GEORGE M.  
JANES &  
ASSOCIATES

July 9, 2013

RE: Zoning commentary on the  
NYCHA pre-RFP releases

### **Carver west site**

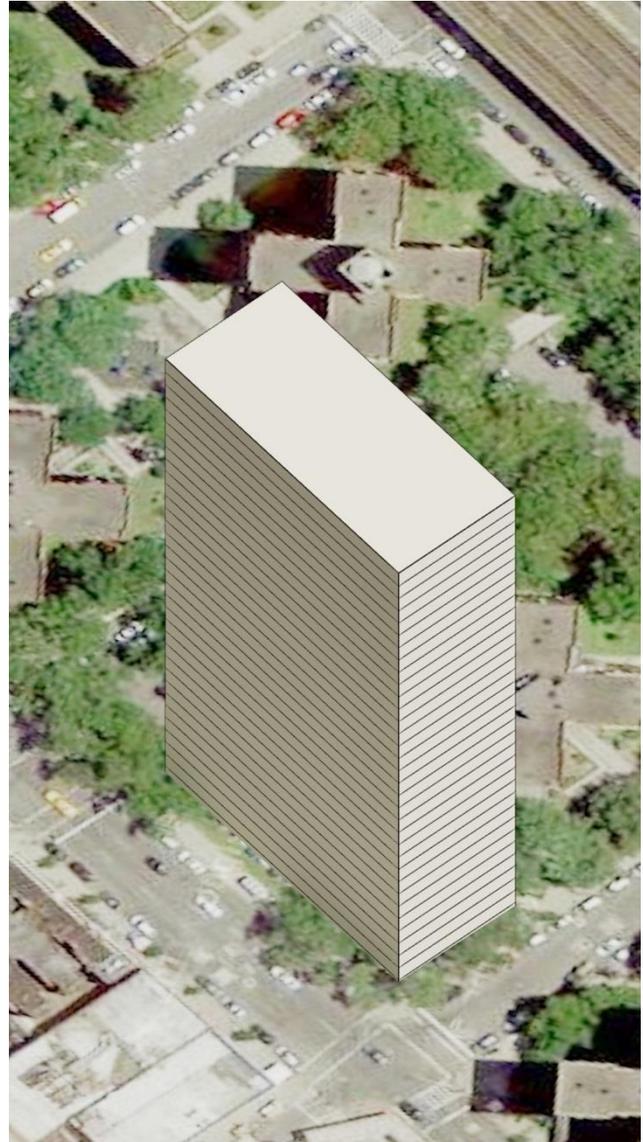
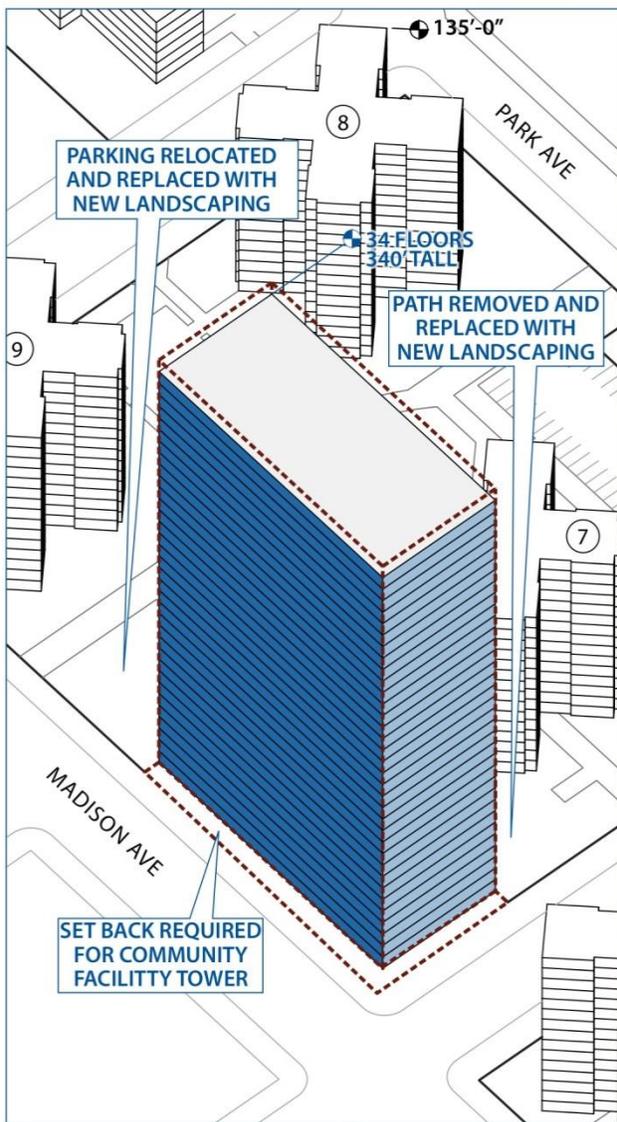
To be able to evaluate the massing shown in the NYCHA document, my office modeled a community facility tower on the west site based upon the massing shown in the NYCHA document. Because of this site's proximity to Mt. Sinai Hospital it is assumed to be more attractive for that use. The image on the left shows the community facility massing as captured from the NYCHA pre-RFP, while the image on the right is the massing my office produced.<sup>1</sup>

The largest issue for the west Carver site is that even though size of the development footprint increases, not all of the floor area available can be accommodated in the community facility tower shown. As modeled, the massing has 462,545 SF of zoning floor area,<sup>2</sup> which assumes that no significant portion of the ground floor is used for accessory parking. If part of the ground floor is used as accessory parking, even more ZFA will have to be accommodated.

The massing could have another floor, a 35<sup>th</sup> story and still be under NYCHA's designated 350 foot height limit and keep the same floor-to-floor height, but that would only add another 13,604 SF of ZFA, leaving it about 24,000 SF of ZFA short. To fully build out the west site using all the community facility space and to stay within the building envelope determined by zoning and NYCHA's height limit, the floor-to-floor heights would have to be compressed by nearly nine inches to add an additional two floors.

NYCHA's massing already shows floors 2 through 34 at under 10 feet floor-to-floor, which while acceptable under zoning, is pushing the reasonable limits of a modern community facility building. A community facility building with 9+ foot floor-to-floor heights will likely break that reasonable limit, or at least restrict the community facility uses that will find the space to be attractive.

The purpose of a massing exercise is to show how a developer might propose a reasonable building, and the western community facility building shown in the NYCHA pre-RFP document is not reasonable since it does not accommodate all the community facility floor area available and would require short floor-to-floor heights if additional floors were added. NYCHA should re-evaluate the massing and adjust it to reflect all the floor area that's available for lease.

### **Carver east site**

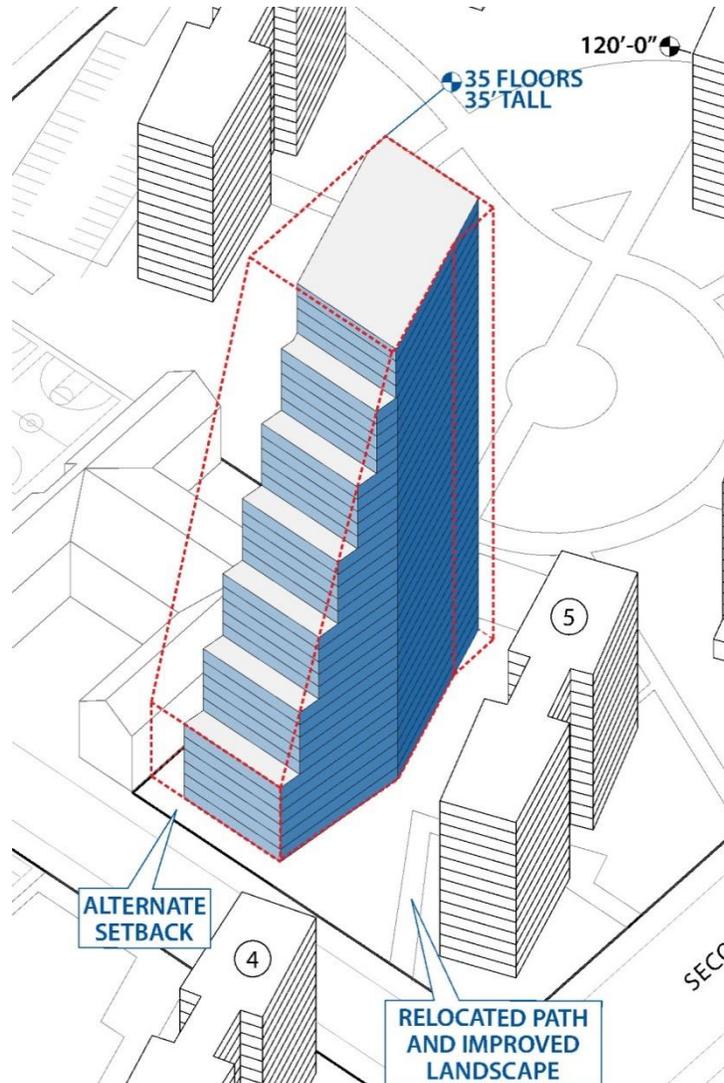
Carver east massing has no issues. It easily fits within the height limit of 300 feet and the required sky exposure planes. The size of the building is within a reasonable margin of the floor area available, assuming that the ground floor is not used primarily for parking.

### **Washington north site**

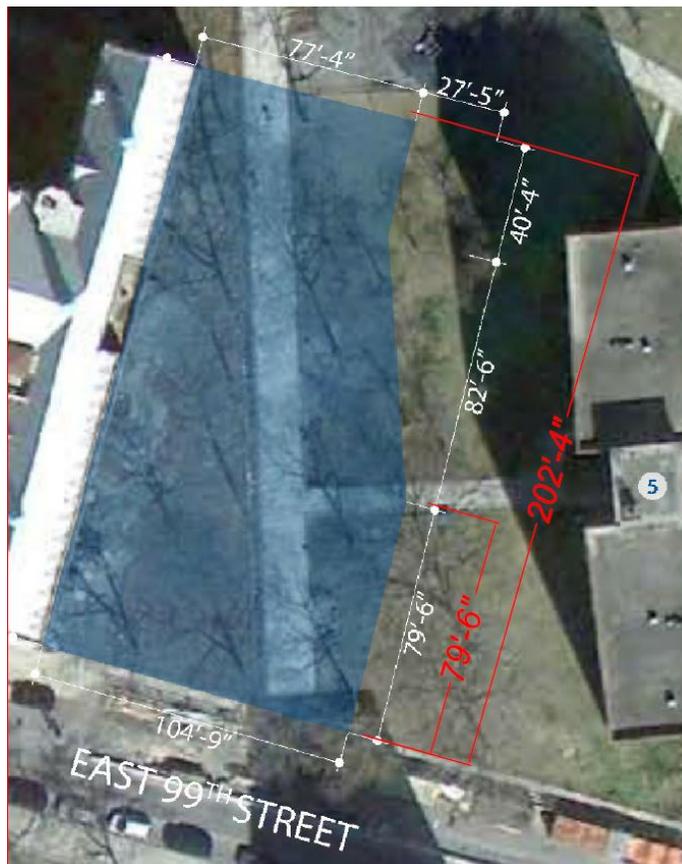
The Washington north site is a difficult site to fit all of the floor area available in the zoning envelope, so there is little flexibility on the building form, yet the massing as shown (reproduced below) has many problems.

First, NYCHA's massing diagram is determined, in part, by the Alternate Setback and sky exposure plane, but the sky exposure plane for the Alternate Setback is shown incorrectly. While the plane is angled correctly, it is set too far back and the massing follows this incorrect plane. The 60 feet starting point of the sky exposure plane is measured at the street line, not at the setback.<sup>3</sup> Correcting for this error, however, will actually make a slightly more buildable building since NYCHA's interpretation pushes the massing back further than necessary.

Second, this massing breaks a side yard zoning requirement. NYCHA's massing shows the building angling back from a side setback straight to the western lot line. While lot line buildings are allowed in this district, if a side yard is provided at any level, it needs to be at least 8 feet;<sup>4</sup> it cannot simply angle back steadily to the side lot line. The building would have to stop angling at 8 feet from the western lot line

and then move perpendicularly to the lot line, or simply continue north leaving at least 8 feet from the side lot line.

NYCHA should modify the massing for this site so that it follows the proper zoning envelope for the Alternate Setback, matches the lease area, and reflects a legal, as-of-right building.

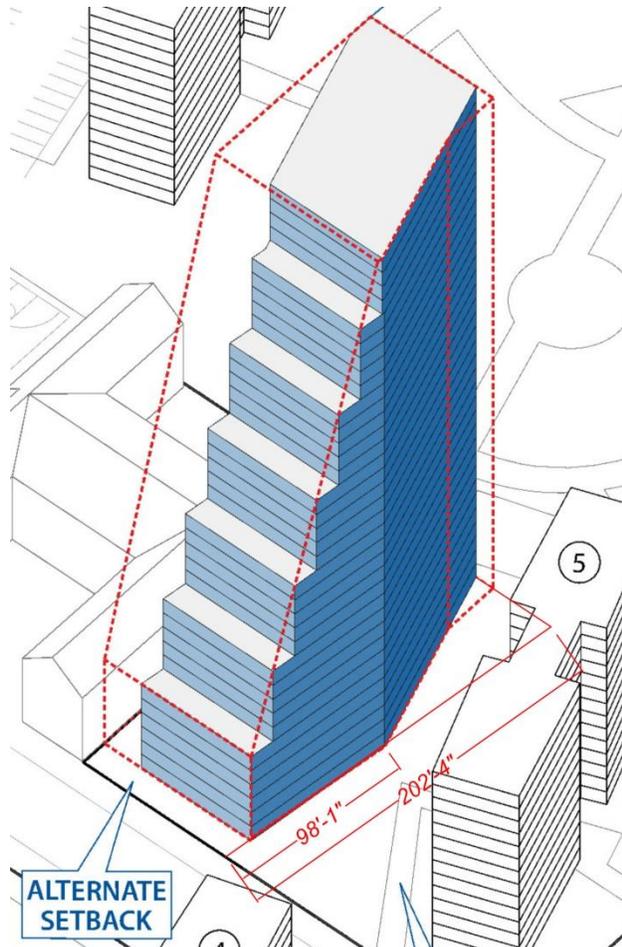
Finally, and most curiously, the massing shown is too big. As a part of evaluating this building my office massed it like the others, and found that it had too much floor area than was being offered for lease. Consequently, we scaled the development footprint to check its measurements against the measurements of the massing shown in the pre-RFP and determined that they were not the same. Below is the lease area scaled in CAD with my office's measurements shown in red on top of NYCHA's measurements in white, and, as expected, they are virtually identical:

But when the base of the massing that appears in the pre-RFP document is similarly scaled, it does not fit into the lease area as shown by the measurements in the red lettering below:

Simply, the massing shown is too big for the lease site, and so its floor area exceeds what is available for lease. We have theorized that the massing was developed for the previously identified lease area and that NYCHA increased its size without updating the building massing.
